SERVICE INSTRUCTIONS

INSTRUCTIONS FOR REPLACING SPARK IGNITION MODULE (Part # 033762) WITH 24V (Part # 058439)

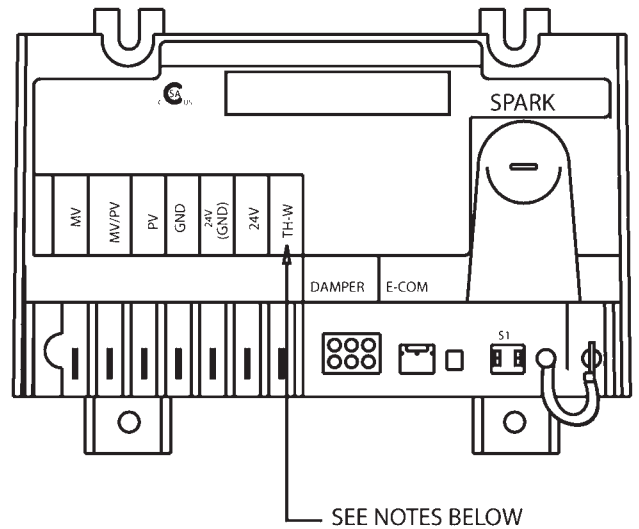
OLD MODULE 033762

NEW MODULE 058439

1. Remove old spark module and mount new module in same location using existing hardware.
2. Place all wires in the same location on the new module, except number 6 "24V". Place this wire on "TH-W" on new module.

- A. Use the supplied wire harness for the GND connection.
 1. Place the "A" terminal on wire harness to the "GND" on the new module.
 2. Place the "B" terminal on the wire harness to the wire that was connected to the "GND" on the old module.

3. Route the "C" terminal and wire to the spark electrode mounting bracket located on the runner pilot tube. Mount the terminal using the screw on the bracket. If the wire is too long, leave the excess wire in the control panel back.

- B. Place the 6 "24V" wire on the "TH-W" on the new module.
3. If the spark terminal on the old module had a boot connection, place the adapter terminal supplied in the module box to the spark electrode wire and connect to the "spark" on the new module.
